PIC24FJ256GB110 Family Silicon Errata and Data Sheet Clarification

The PIC24FJ256GB110 family devices that you have received conform functionally to the current Device Data Sheet (DS39897C), except for the anomalies described in this document.

The following typographic corrections and clarifications are to be noted for the latest version of the device data sheet (DS39897C):

FIGURE 2-3 FREQUENCY vs. ESR PERFORMANCE FOR SUGGESTED VCAP

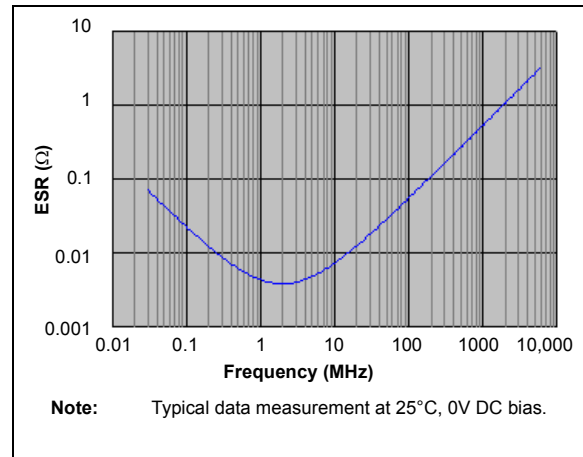
Section 2.4 Voltage Regulator Pins (ENVREG/DISVREG and VCAP/VDDCORE) has been replaced with a new and more detailed section. The entire text follows:

Designers may use [Figure 2-3](#) to evaluate ESR equivalence of candidate devices.

When the regulator is enabled, a low-ESR ($< 5\Omega$) capacitor is required on the VCAP/VDDCORE pin to stabilize the voltage regulator output voltage. The VCAP/VDDCORE pin must not be connected to VDD and must use a capacitor of 10 μF connected to ground. The type can be ceramic or tantalum. Suitable examples of capacitors are shown in [Table 2-1](#). Capacitors with equivalent specifications can be used.

FIGURE 2-4 DC BIAS VOLTAGE vs. CAPACITANCE CHARACTERISTICS

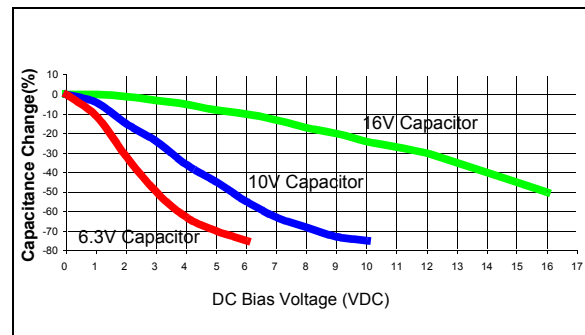
A typical DC bias voltage vs. capacitance graph for 16V, 10V and 6.3V rated capacitors is shown in Figure 2-4.

When selecting a ceramic capacitor to be used with the internal voltage regulator, it is suggested to select a high-voltage rating, so that the operating voltage is a small percentage of the maximum rated capacitor voltage. For example, choose a ceramic capacitor rated at 16V for the 2.5V core voltage. Suggested capacitors are shown in Table 2-1.

FIGURE 29-1: PIC24FJ256GB110 FAMILY VOLTAGE-FREQUENCY GRAPH (INDUSTRIAL)

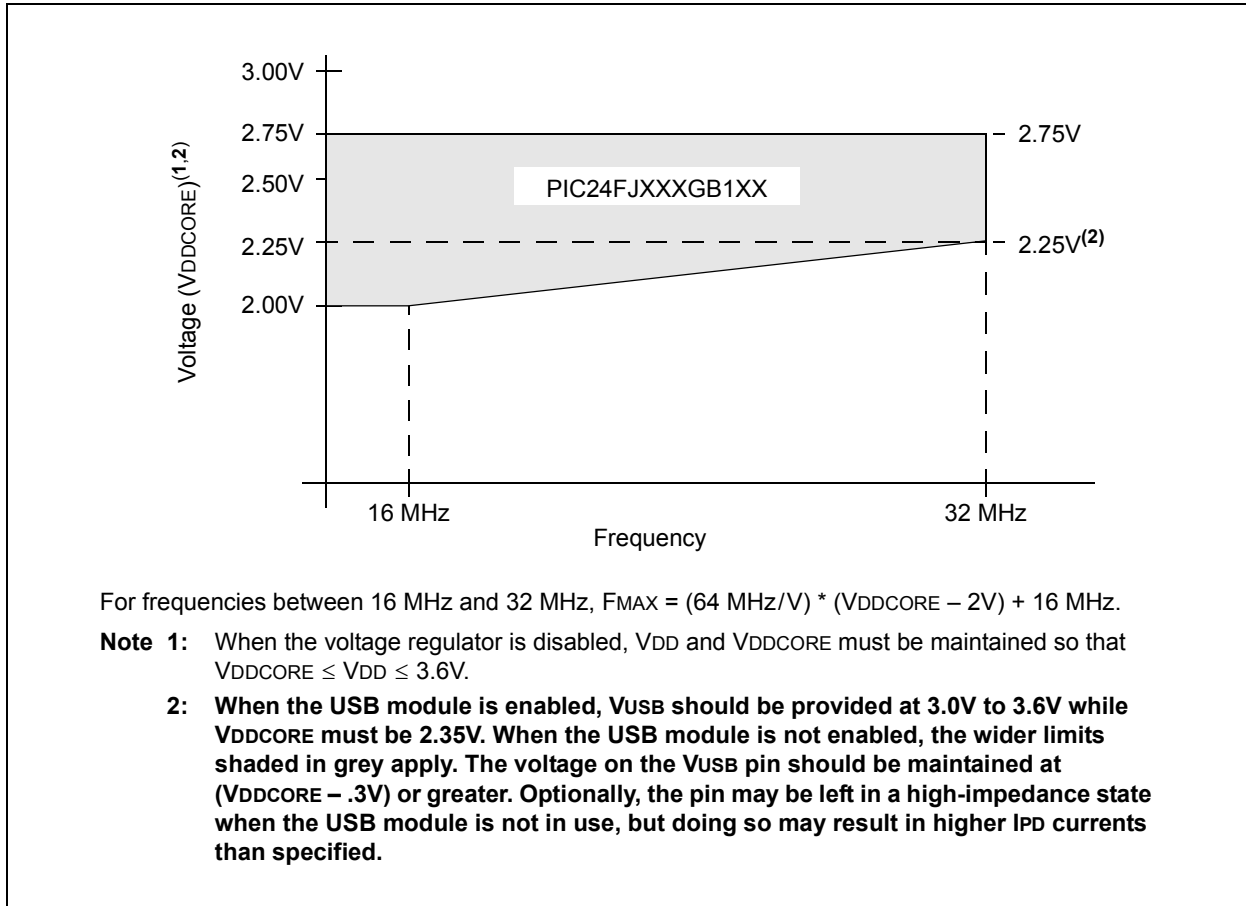
Figure 29-1 (“PIC24FJ256GB110 Family Voltage-Frequency Graph”) is amended by adding an additional footnote. The updated figure is shown below (changes in **bold**; bold in original removed for clarity).
